HISTORIC DISTRICT COMMISSION

APPLICATION FOR WORK APPROVAL

HDC2025-00315

ADDRESS(ES): 2998 Iroquois Ave.

A16

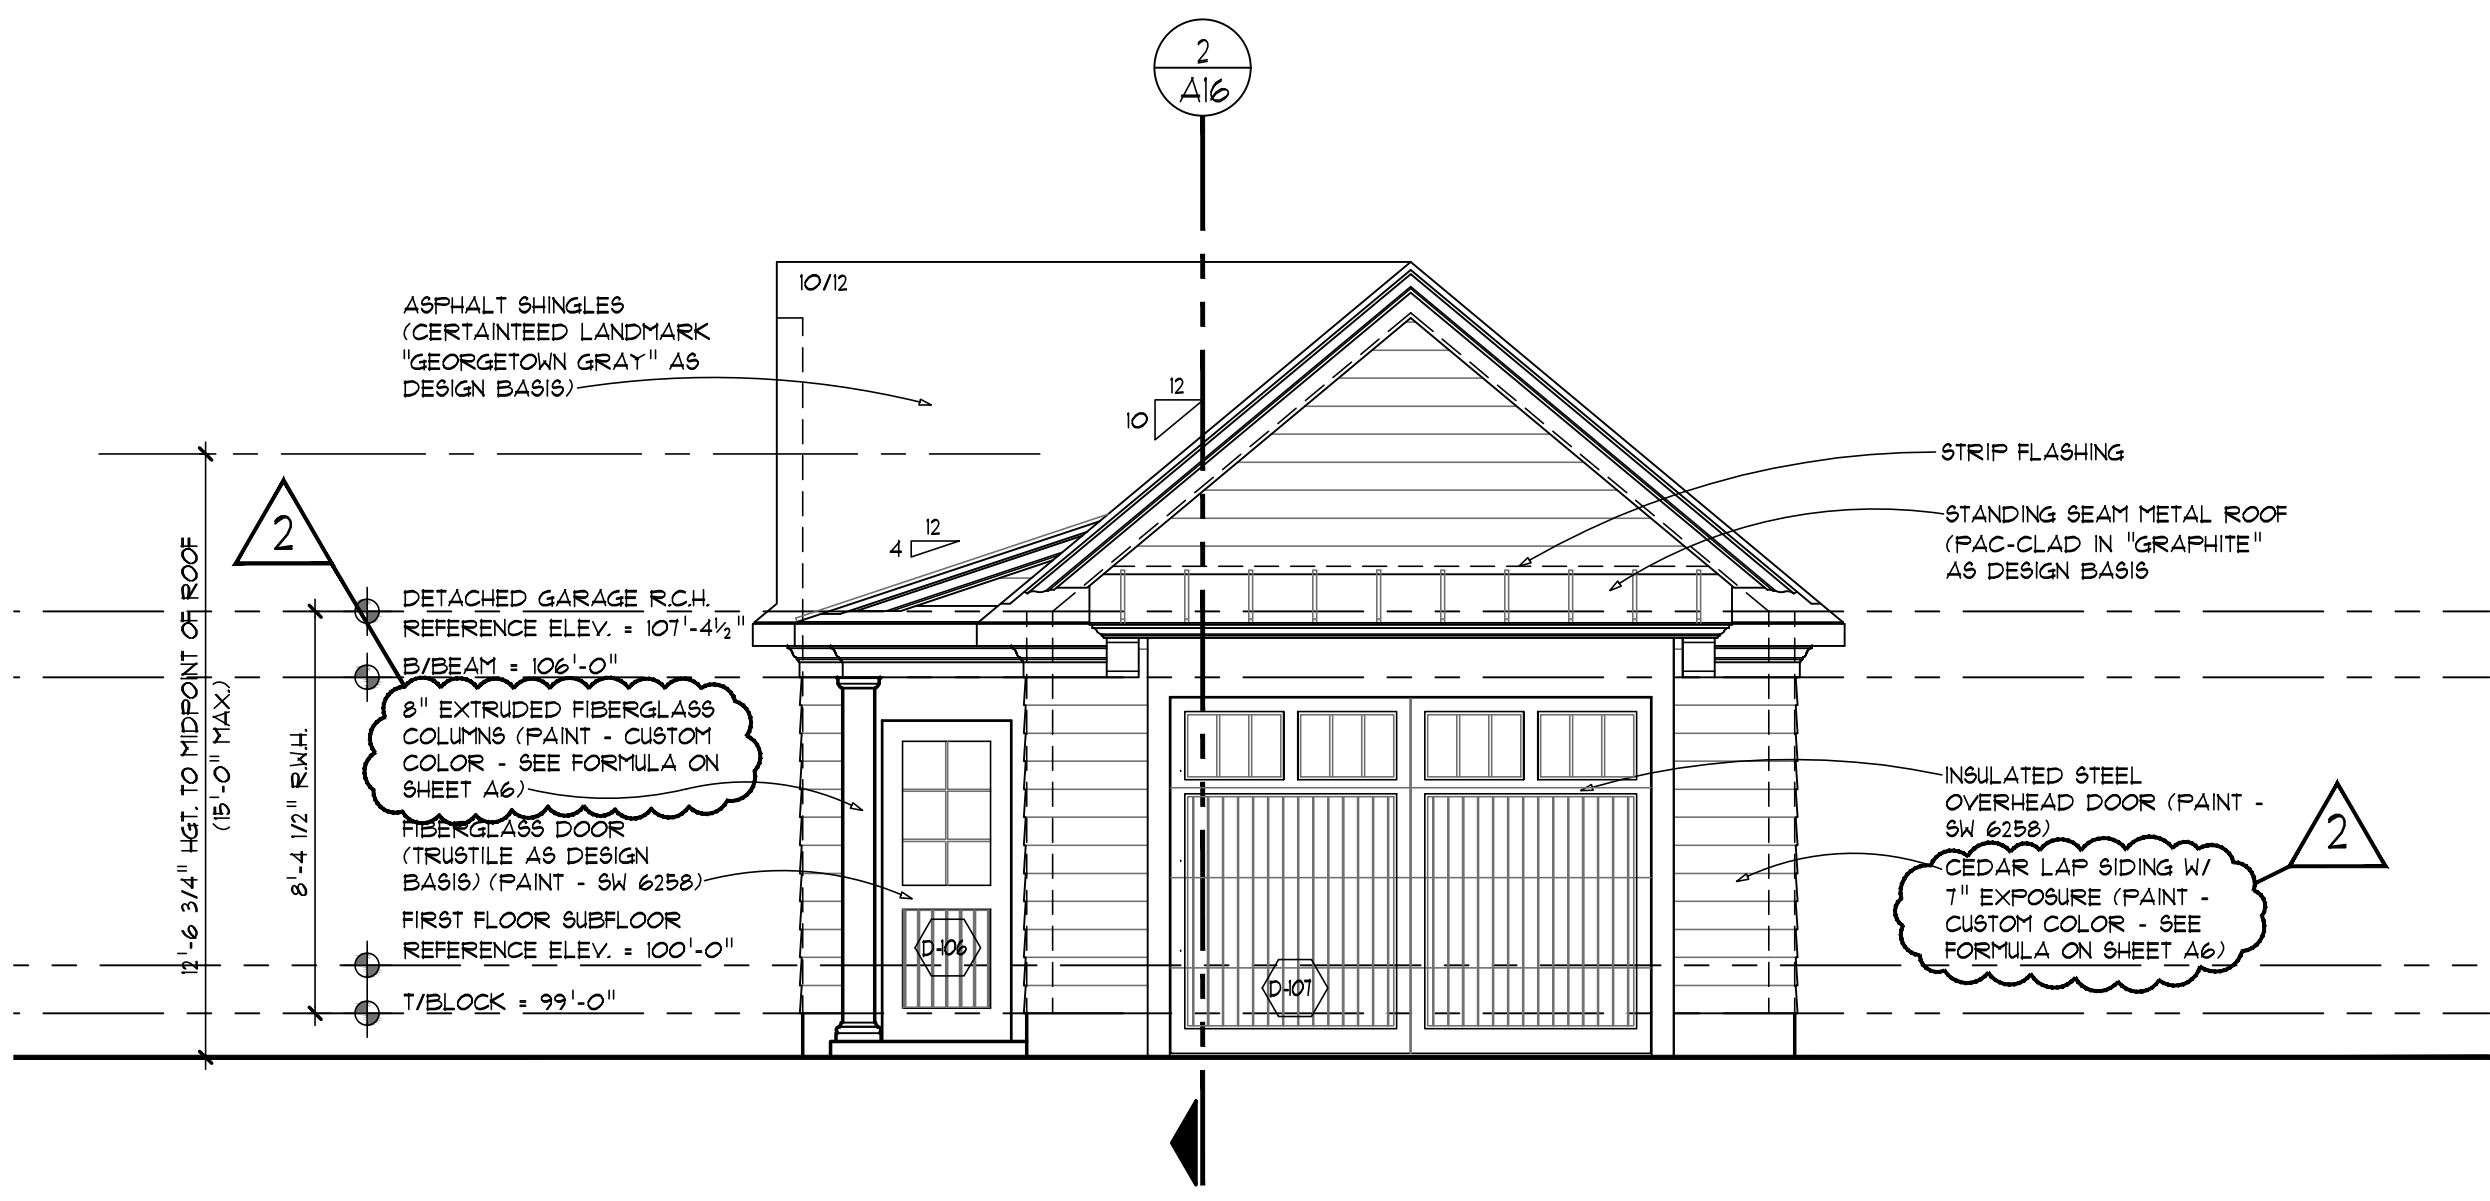
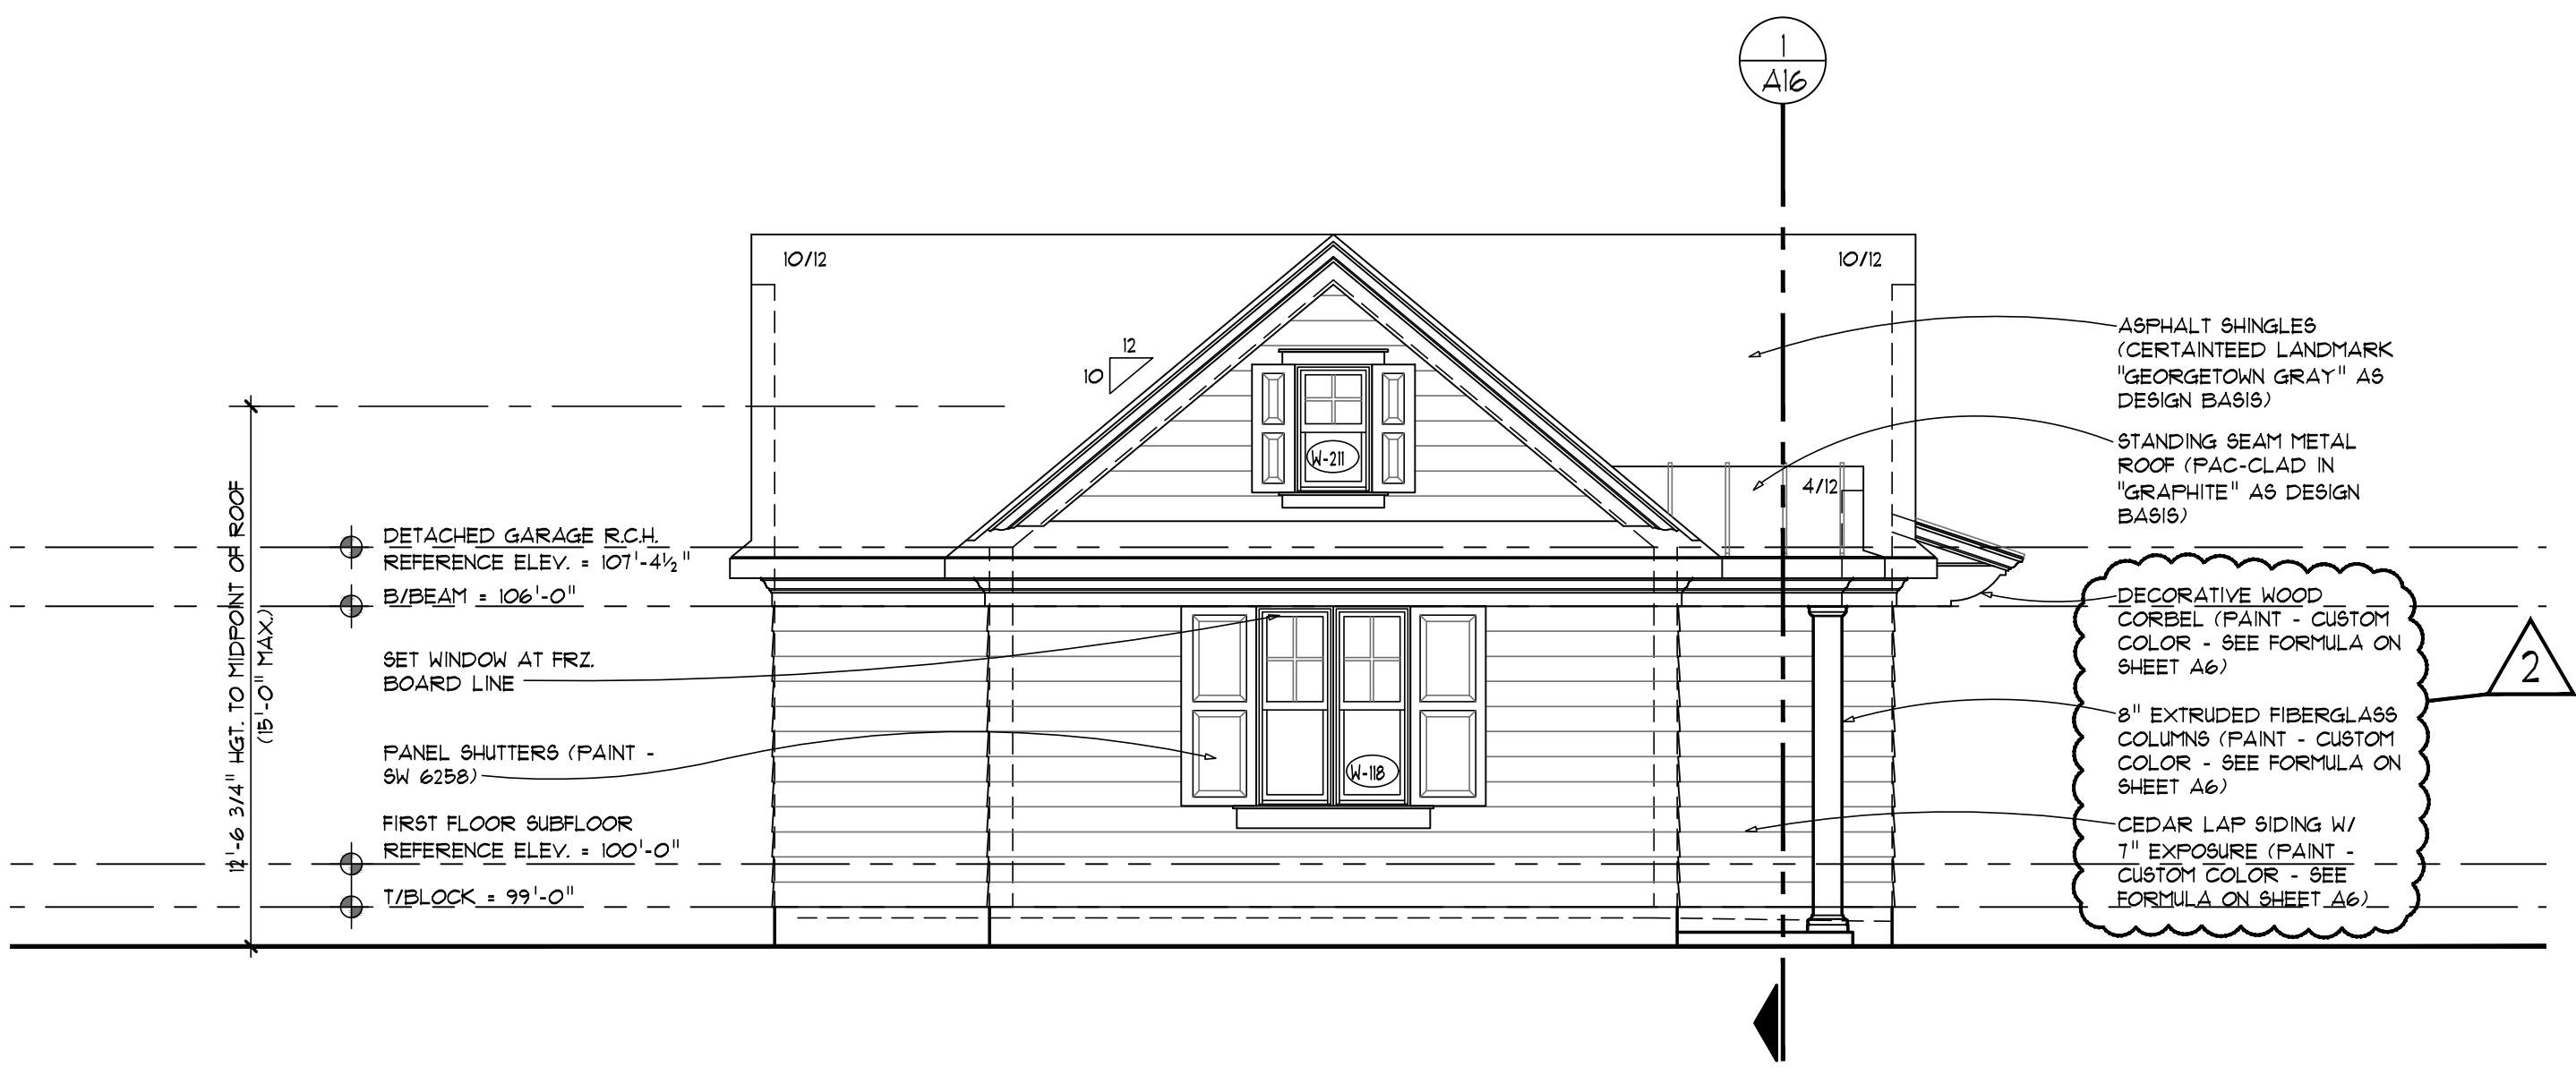
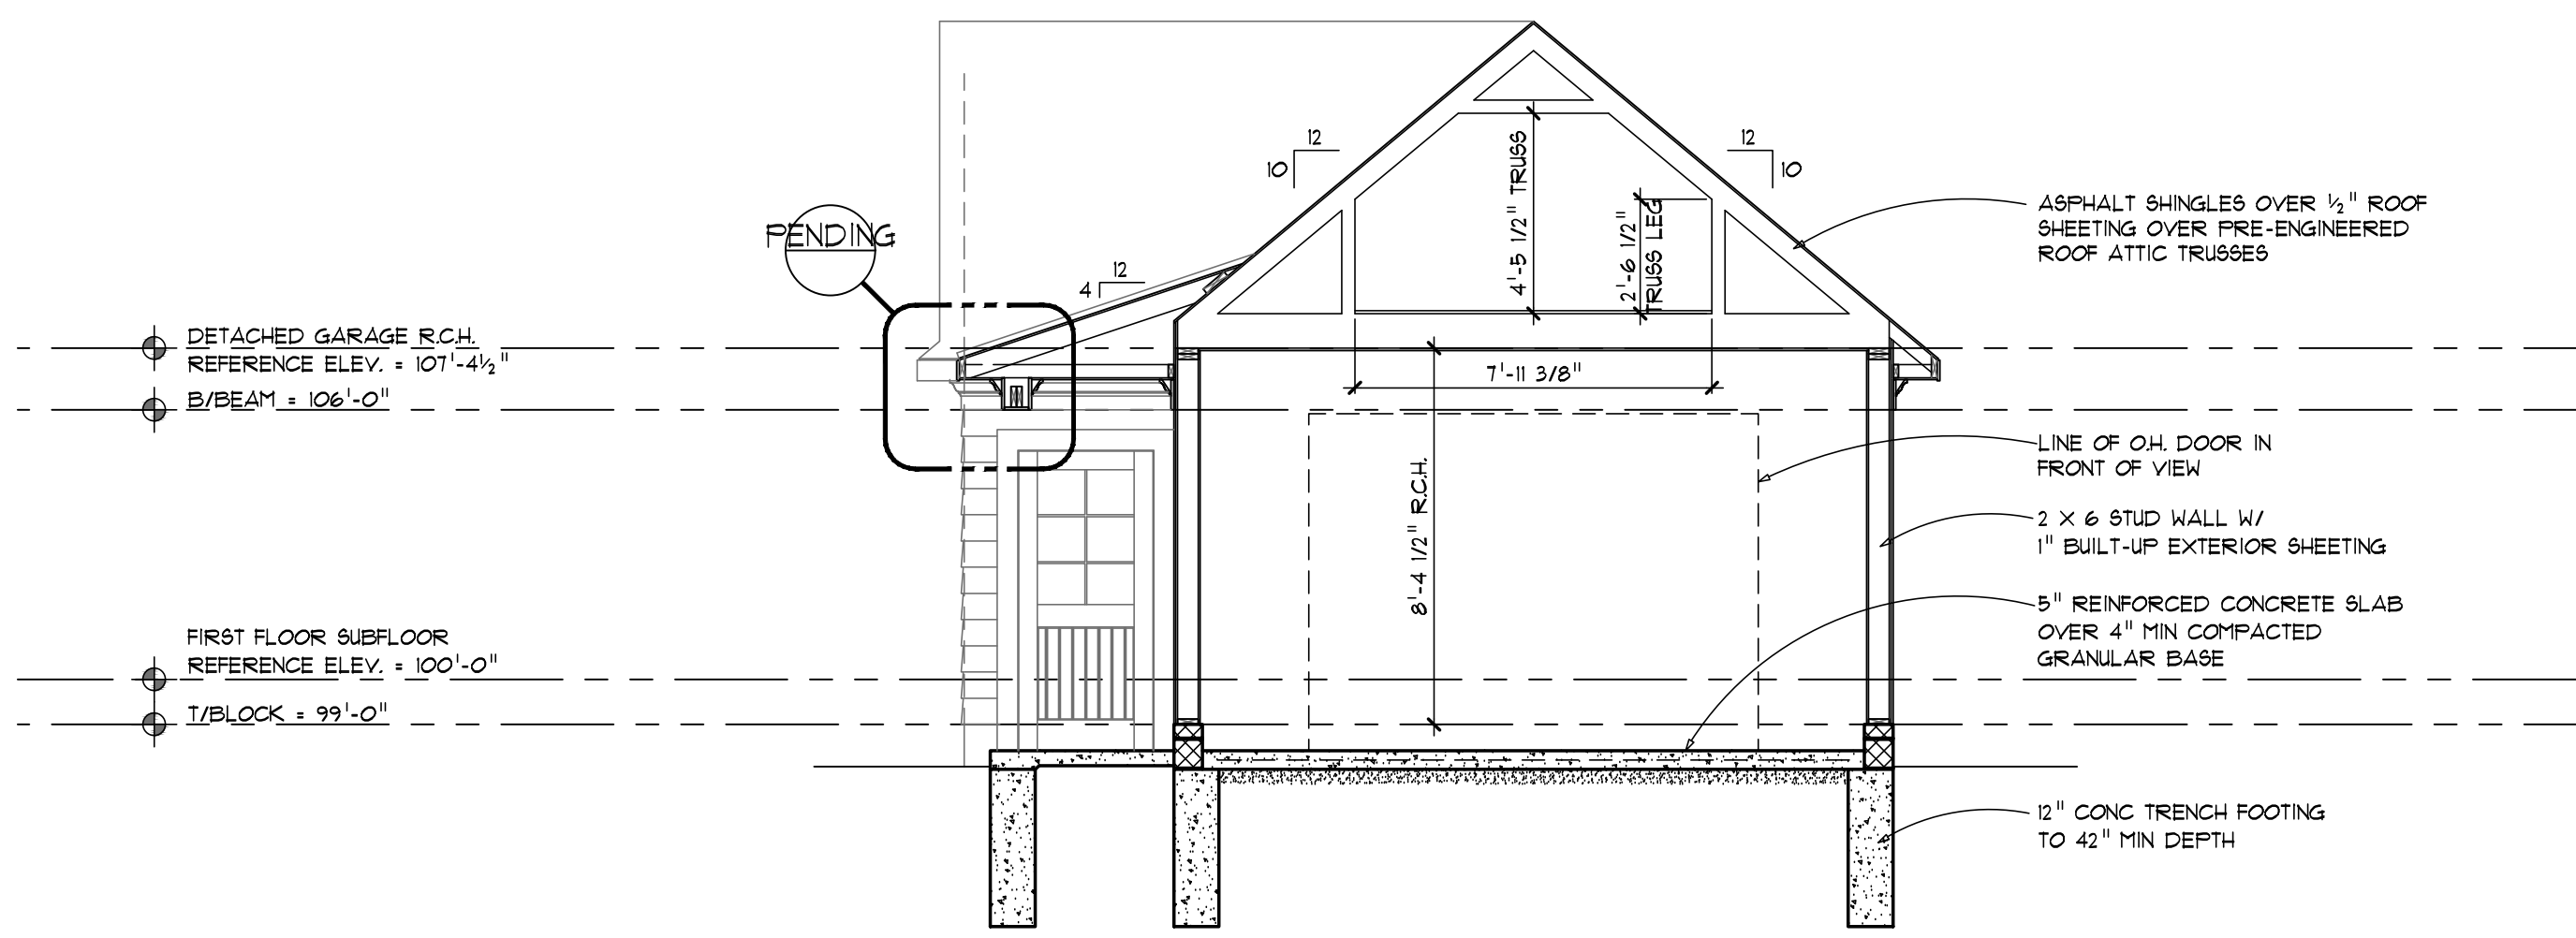
1. Permit Revision- 11.10.2023
2. Color Revision- 06.04.2025
